Westinghouse
Electric Corporation

RE-EKR-89-055

Subject: Application for Amendment for Certificate of Compliance
No. 5450 (Docket 71-5450)

The Westinghouse Electric Corporation hereby submits this revised application for an amendment to Certificate of Compliance No. 5450 (Docket No. 71-5450) for the RCC fuel shipping container. The only changes requested as part of this application are to increase the authorized maximum U-235 enrichment for Westinghouse 17x17 12-foot OFA fuel designs from 4.3 wt % to 4.45 wt % for two separate conditions. Either each assembly contains a minimum of 32 Integrated Fuel Burnable Absorber (IFBA) rods per specification and loading pattern described in Westinghouse drawing SKA-89044, or there is only one assembly shipped per container. These fuel shipments will be limited to the RCC type containers with Gadolinium Oxide poison plates.

IFBA (32) LOAD PATTERN & DETAILS
TITLE FOR 4.45 WT% 17 OFA FUEL ASSY

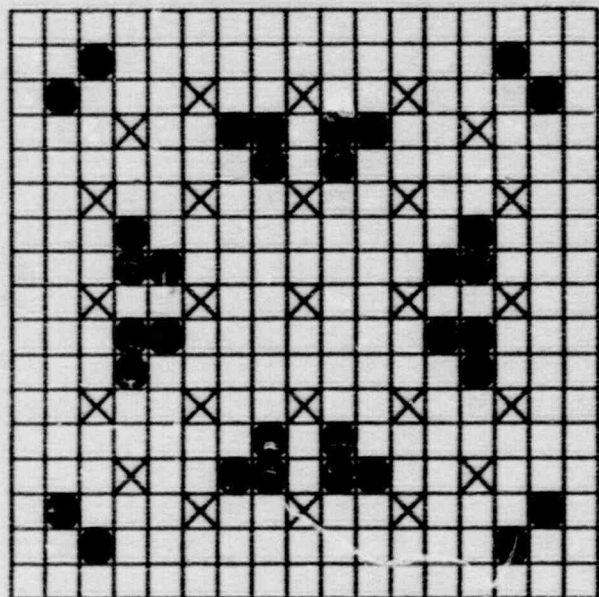
Attachment 19 has been revised to justify this U-235 enrichment increase from 4.30 wt % to 4.45 wt % with one assembly per container or with a minimum of 32 IFBA rods per assembly located in accordance with Westinghouse drawing SKA-89044. The calculated K-effective with the inclusion of a 95/95 confidence level (bias and uncertainties in the calculation and benchmark) are below 0.950.

The basic IFBA load pattern is provided in attached Westinghouse Drawing SKA-89044. This load pattern shows that all of the IFBA rods are located internal to the assembly. Thus, the outer rods will provide impact and thermal shielding for all IFBA rods in the MCA test.

(1) Load pattern per Westinghouse Drawing SKA-89044.
